8 April 2014

**ADDENDUM #3**

**Addition and Renovations to  
Eastern West Virginia Community & Technical College  
Moorefield, West Virginia**

**RFB 14101**

Item #5 Drawing E701 – Elevation “A-A” and Elevation “B-B”

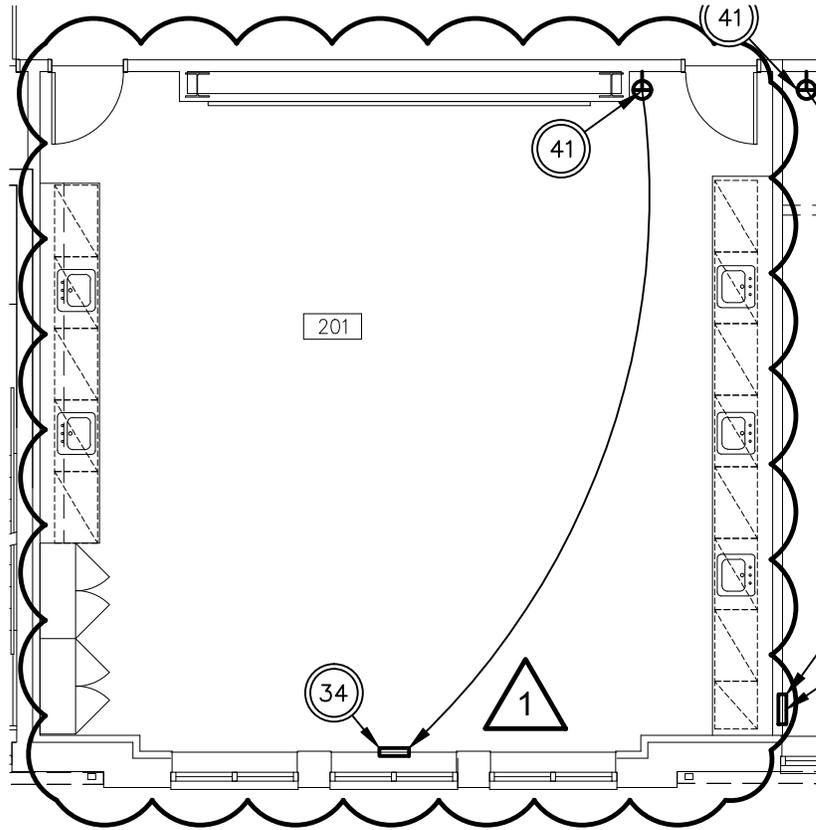
A. Refer to attached sketches for revisions to these elevations.

**AD3-H1**

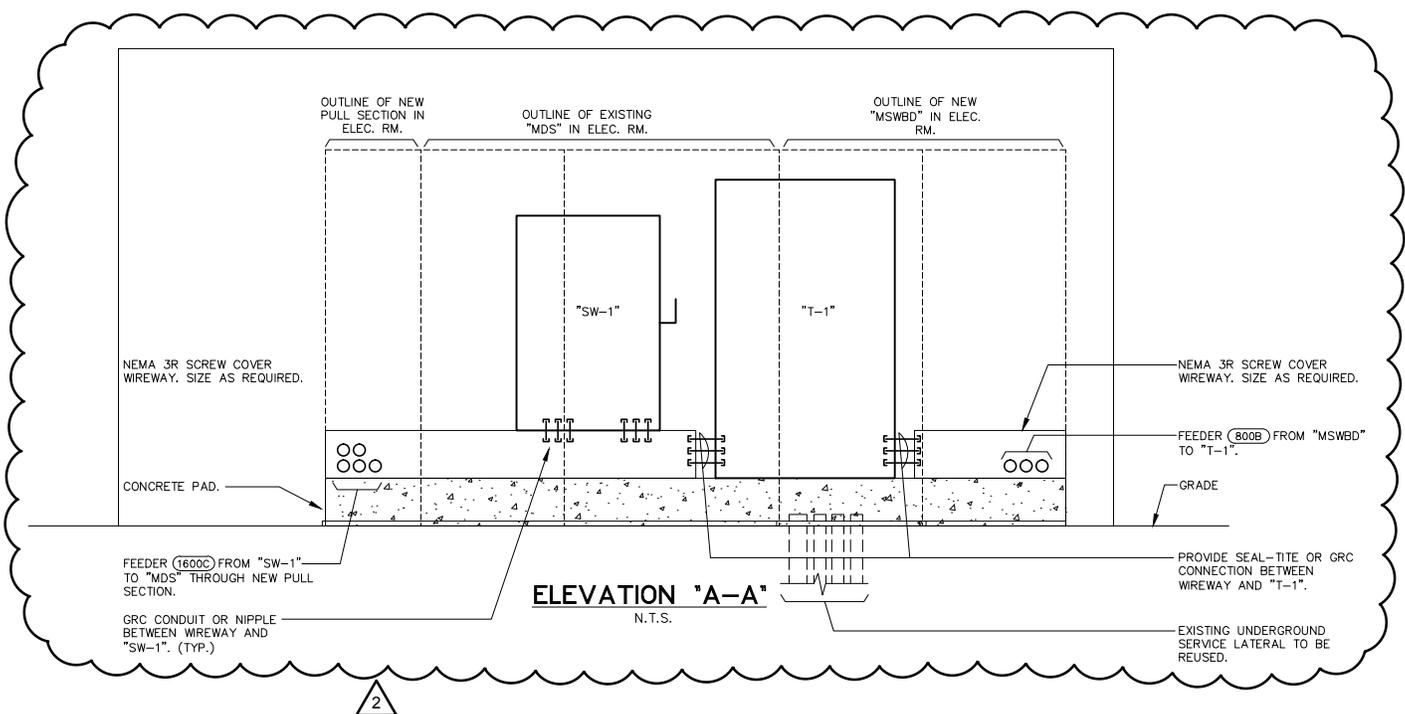
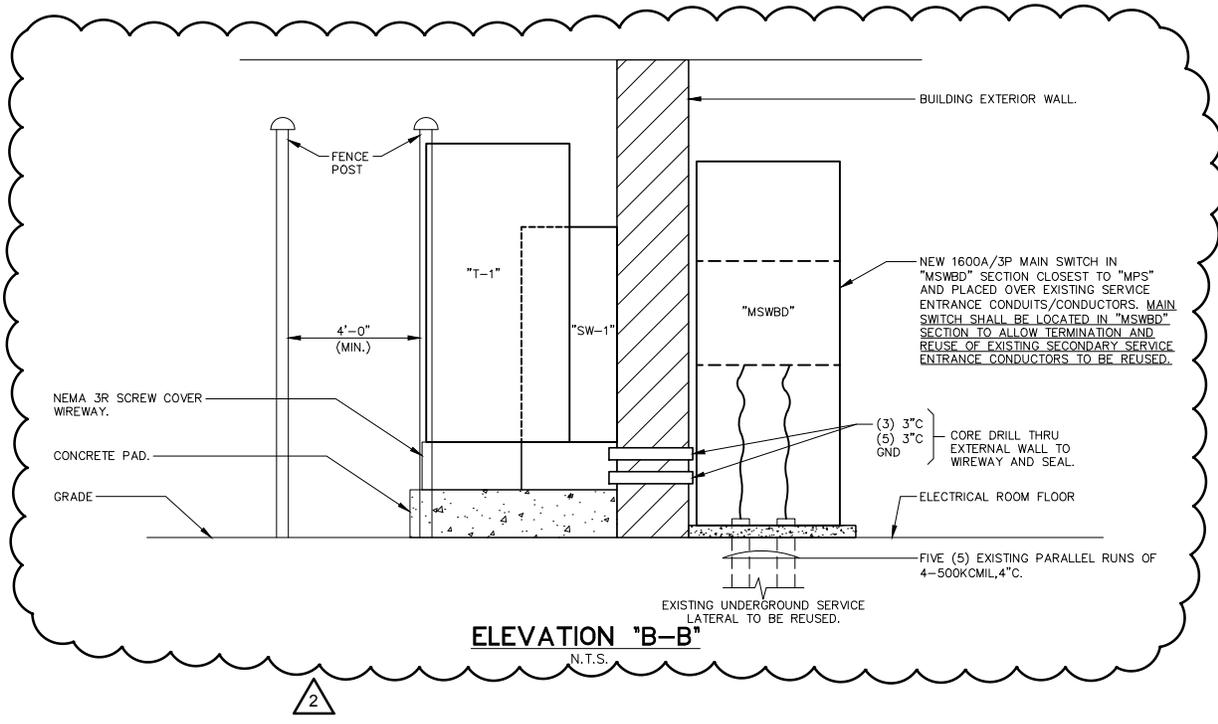
- Item #5 Drawing H501 – New Work – Second Floor Plan - HVAC
- A. Refer to attached Sketch AD3-H1. In existing room 201, add electric wall heater “A-EWH-1” and associated thermostat.

- 34. INSTALL ELECTRIC WALL HEATER "A-EWH-1" IN EXISTING WALL. SEE DETAIL
- 41. "NETWORKED" THERMOSTAT TO CONTROL "A-EWH-1".

**LETOP BOX OUTLET**  
N.T.S.

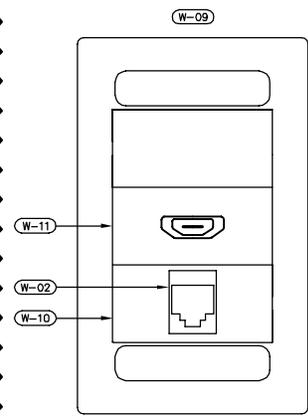
A. Refer to attached sketch for revisions to the Workstation Material Notes and the Telecom Outlet Details.
